Hematite Decommissioning Plan Chapter 6 - Environmental Information

Hematite Decommissioning Plan Chapter 7 – ALARA Analysis

Figure 2
Recent Sample Locations for Site Creek

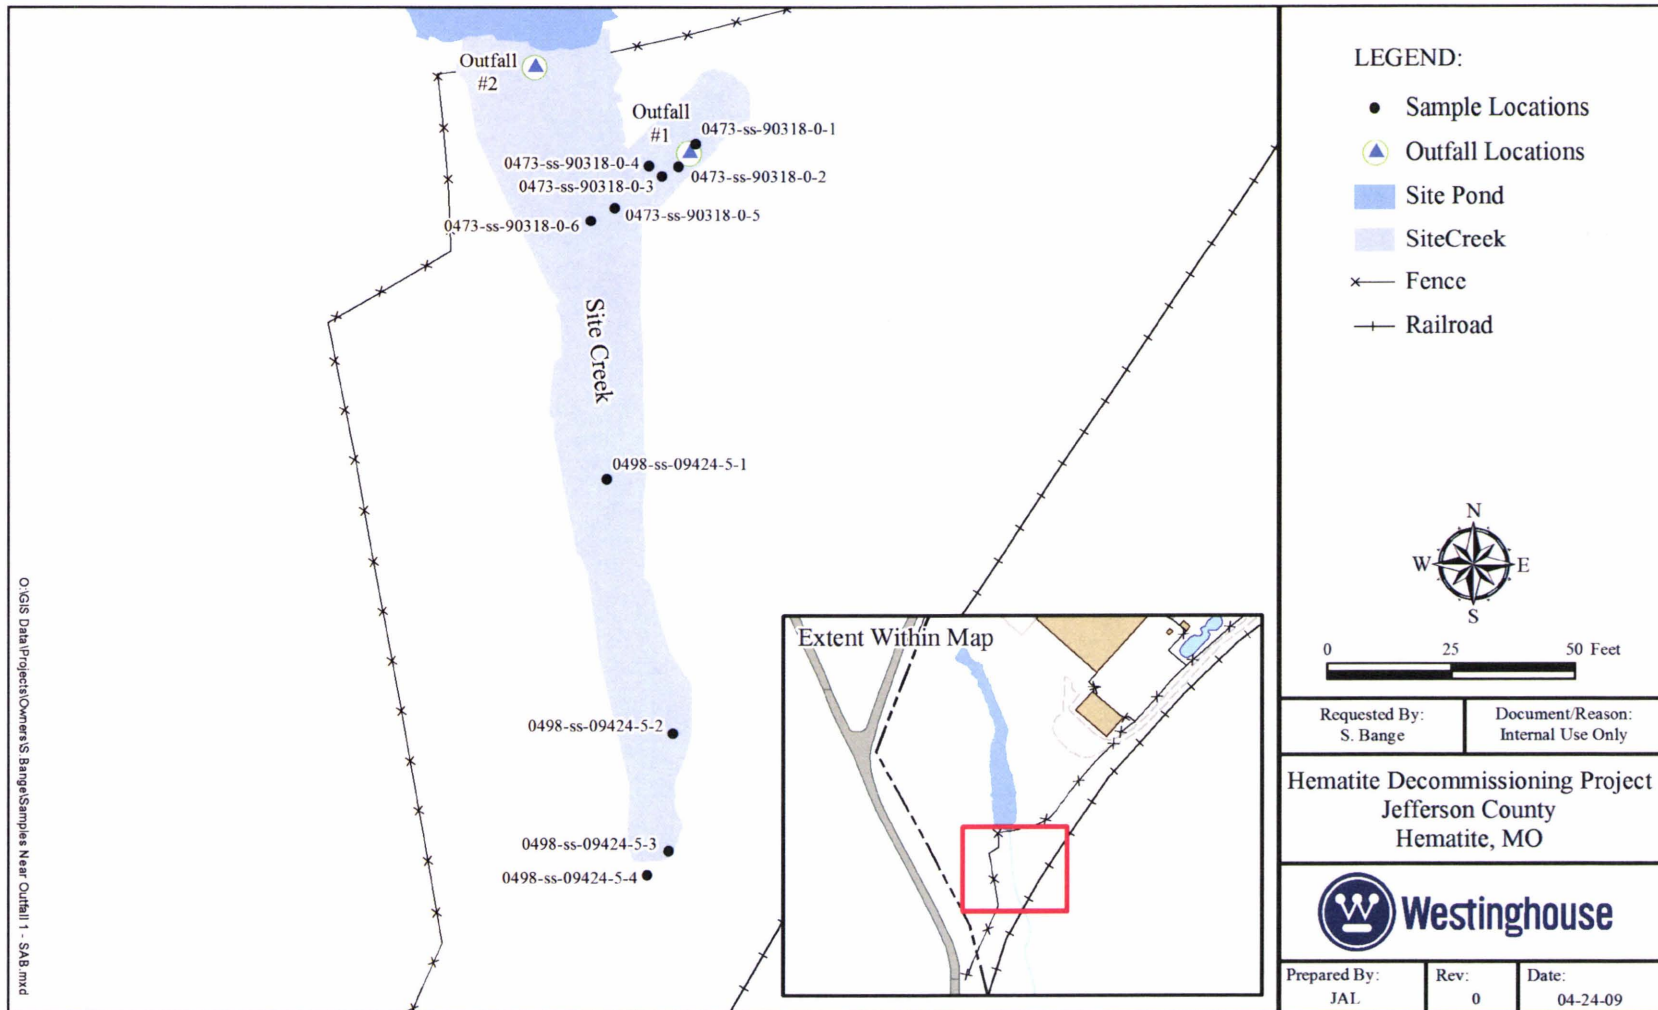
2. (HDP-6-Q2) Comment: In HDP Section 6.1.2, it is stated that the Site Creek/Pond and the Northeast Site Creek could potentially require remediation to remove contamination in sediment and nearby soil. Given this uncertainty, there is a potential for inadequate financial assurance since those decommissioning tasks are ill defined.

Path Forward: Describe the remediation actions which will be taken for the Site Creek/Pond and the Northeast Site Creek. If actions have not been determined, provide which actions are under consideration and describe how these potential actions have been accounted for with respect to ensuring adequate decommissioning funding.

Remediation actions to be taken for contamination in soil/sediment within the Site Creek may extend from the south side of the Site Pond Dam to the railroad culvert crossing. The most recent radiological characterization data for the Site Creek southeast of the Site Pond concrete dam and Outfall #1 indicate the presence of isolated residual contamination that would exceed the proposed surface DCGLs. Table 2 below presents the radiological sampling data obtained from the portion of the Site Creek between the downstream side of the concrete dam and Outfall #2, to the railroad culvert. Analytical results for Samples 0473-SS-90318-0-5 and 0472-SS-90318-0-6, indicate that sediments and surrounding soils from these locations exceed the Sum of Fraction (SOF) for the proposed Surface Derived Concentration Guideline Limits (DCGLs) for Uranium 234, U-235+D, and U-238+D. Samples were collected to a depth of 6-inches. Figure 2 below illustrates the location of the samples collected from the area of the Site Creek.

Based upon this newly available data, it is expected that the area of the Site Creek immediately downstream of the Site Pond concrete dam and Outfall #1 will be excavated to a distance of roughly 50-feet downstream, and to a width of roughly 25-feet. The excavation is expected to be performed to a 1-foot depth. Estimated waste volumes from the excavation are 1,250 cubic feet.
